# GLENVIEW PUBLIC SCHOOL - GYM ADDITION

CITY OF BURLINGTON  
BUILDING SERVICES  
REVIEWED  
FOR PERMIT ISSUANCE  
DATE July 10/2024  
PERMIT NUMBER 24 008616  
EXAM Ark

ISSUED FOR BUILDING PERMIT SUBMISSION

1 SECTION DETAIL - ROOF ACCESS LADDER  
A602 1:20

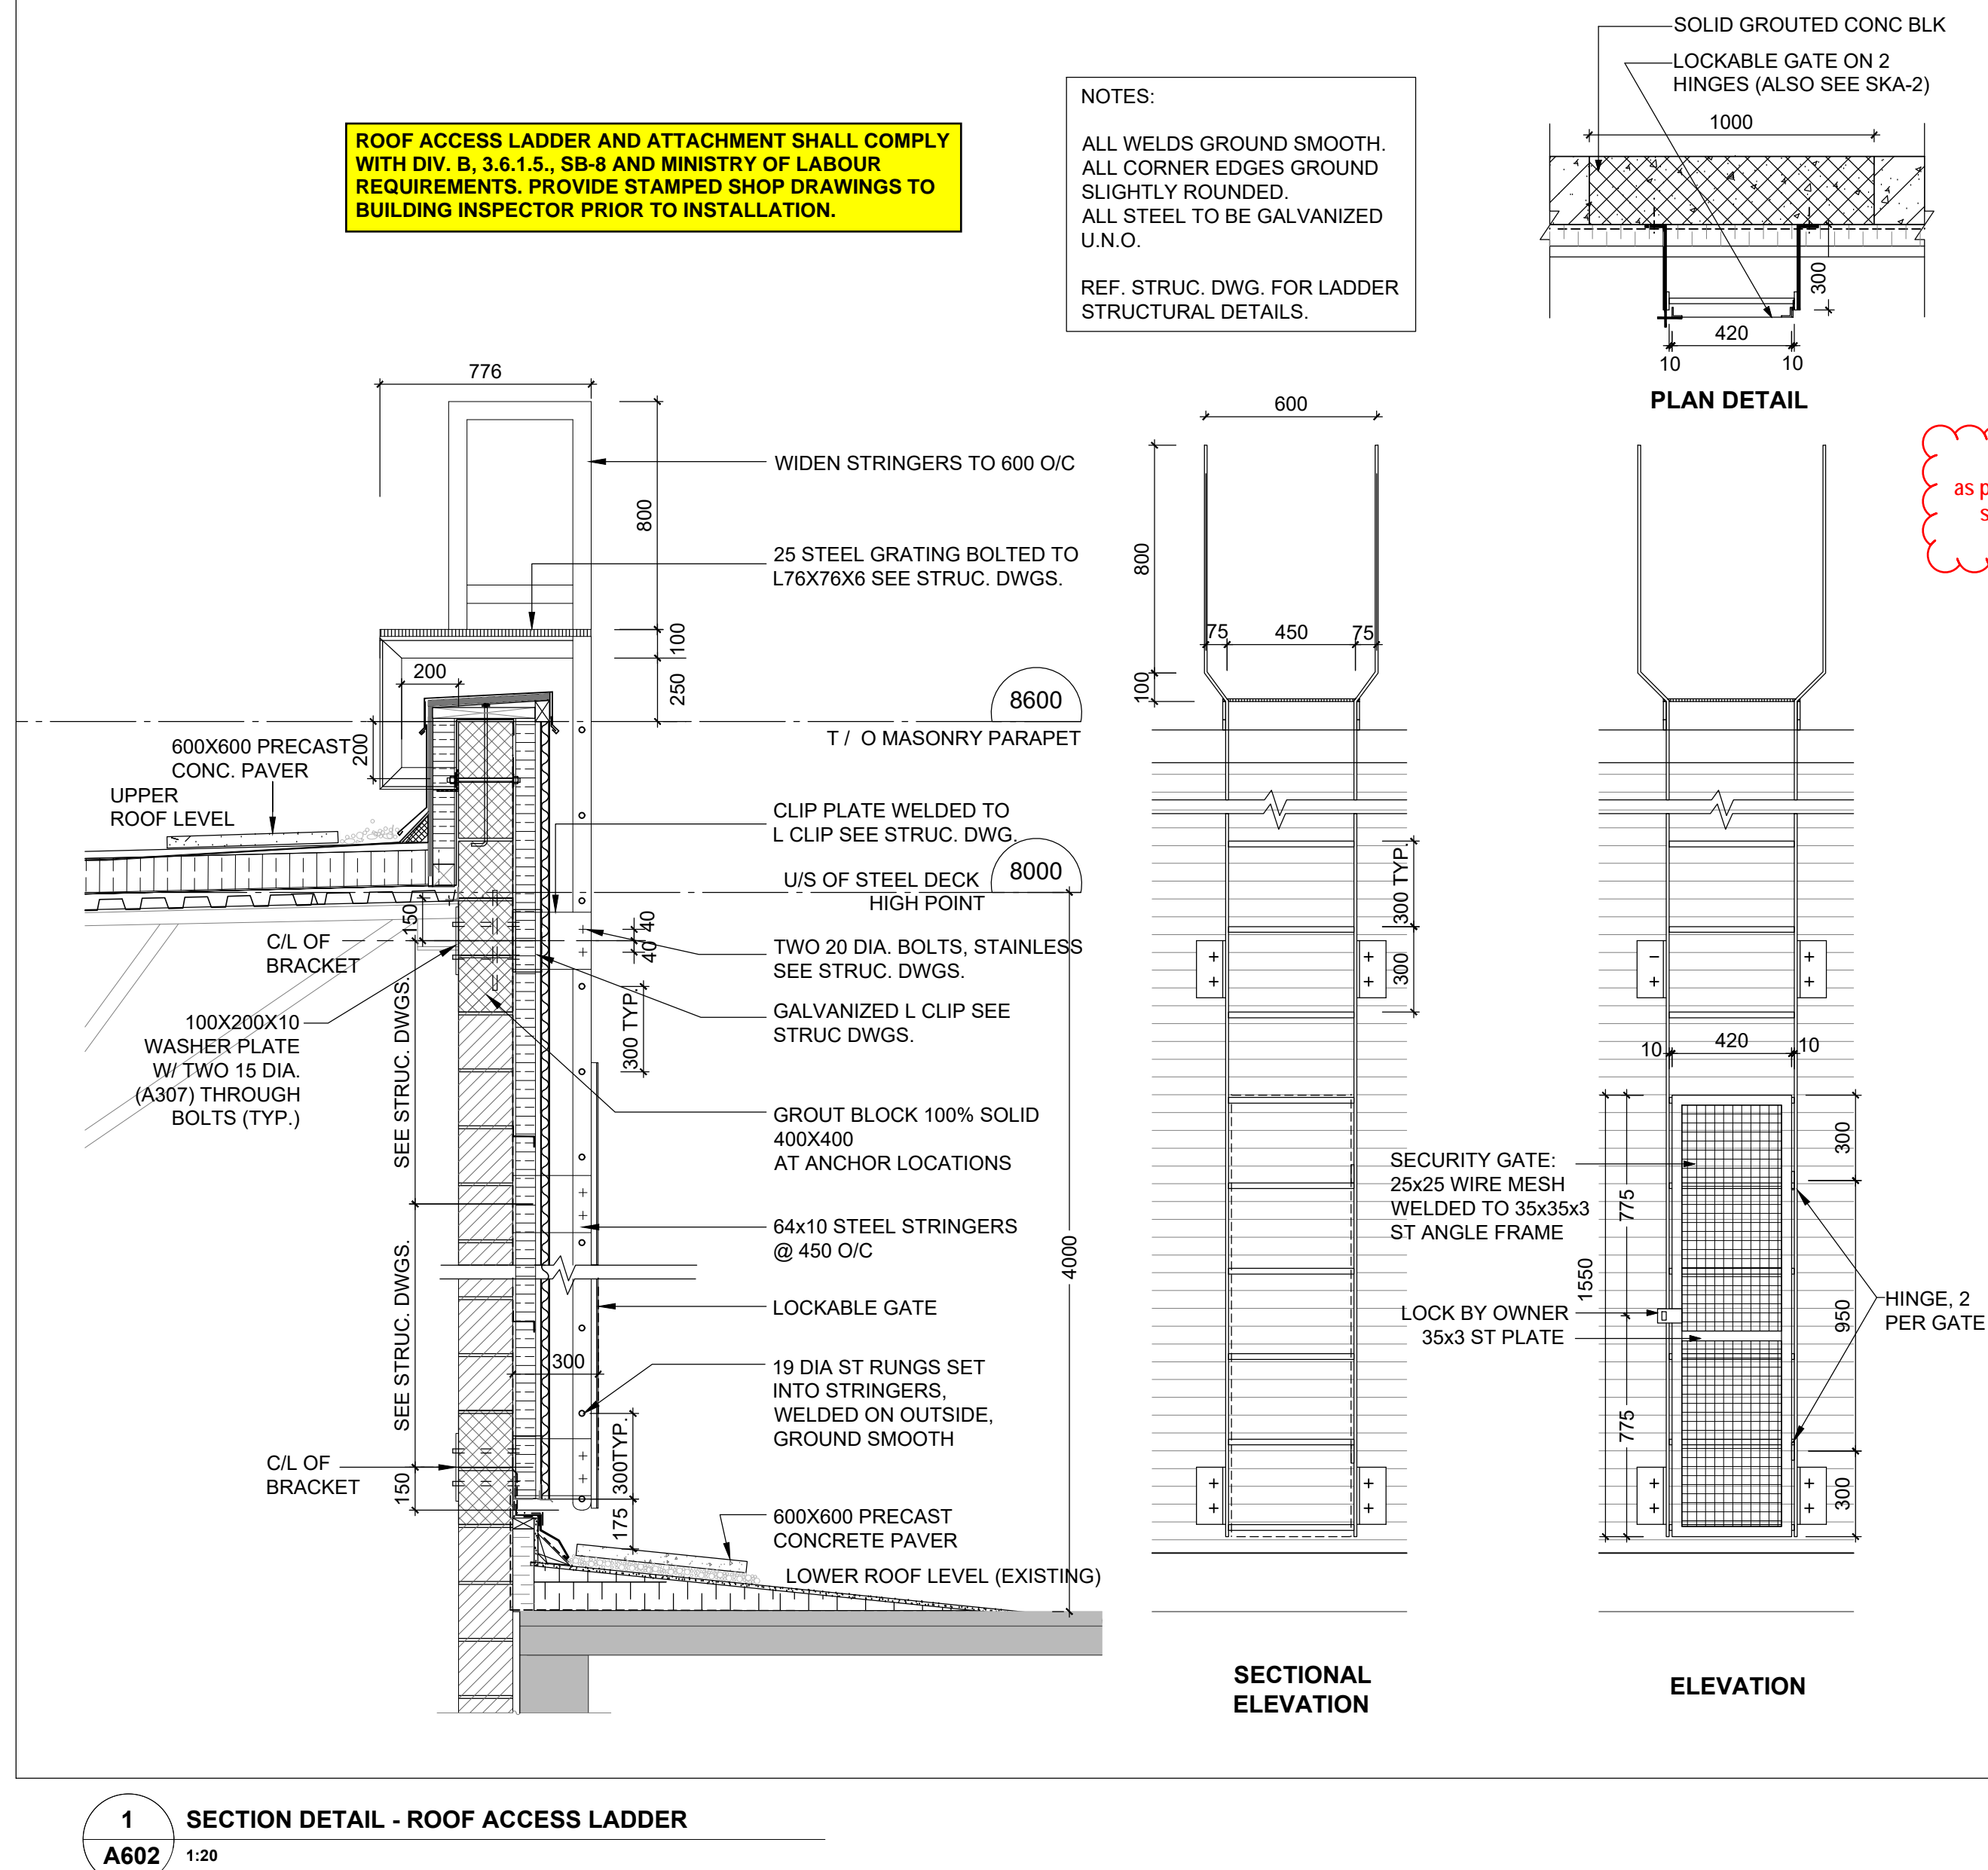
Provide safety cage around ladder as per Ministry of Labour requirement. Please see attached document/specifications.
